Docket Item #'s 14 & 15  
BAR CASE # 2005-0200  
BAR CASE #2005-0201

BAR Meeting  
October 5, 2005

**ISSUE:** Exterior Alterations & a Waiver of Rooftop HVAC Screening

**LOCATION:** 811 Prince Street

**Figure 2** Proposed south elevation

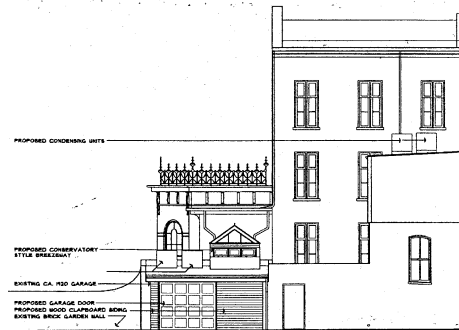
In the front part of the house, the features proposed for alteration include a new iron gate installed in a new opening in the existing masonry garden wall. The gate would be comprised of two leaves, with a solid decorative panel below and an open rail section above, hung from new masonry piers. The new gate would align with a new metal stair structure which will provide access to the east wing of the house from the garden. This light stair structure will be painted and is intended to replace the heavy masonry stair which currently obscures the architecture of the east wing porch or galleria. The approach to the stair will be enclosed behind a short section of new masonry wall perpendicular to the existing wall and will abut the wood framed east wing at the corner. This arrangement will permit the decorative panels below the sill of the east wing to become once again visually accessible from the street as they were historically, until enclosed in the 1960's.

The only area which might be rethought is the short section of new masonry wall abutting the wood porch; in the absence of large scale details, this junction is a concern. The thought here is that a more appropriate response might be to consider the use of an open iron railing similar to that used on the new gate and entry stoop from the garden.
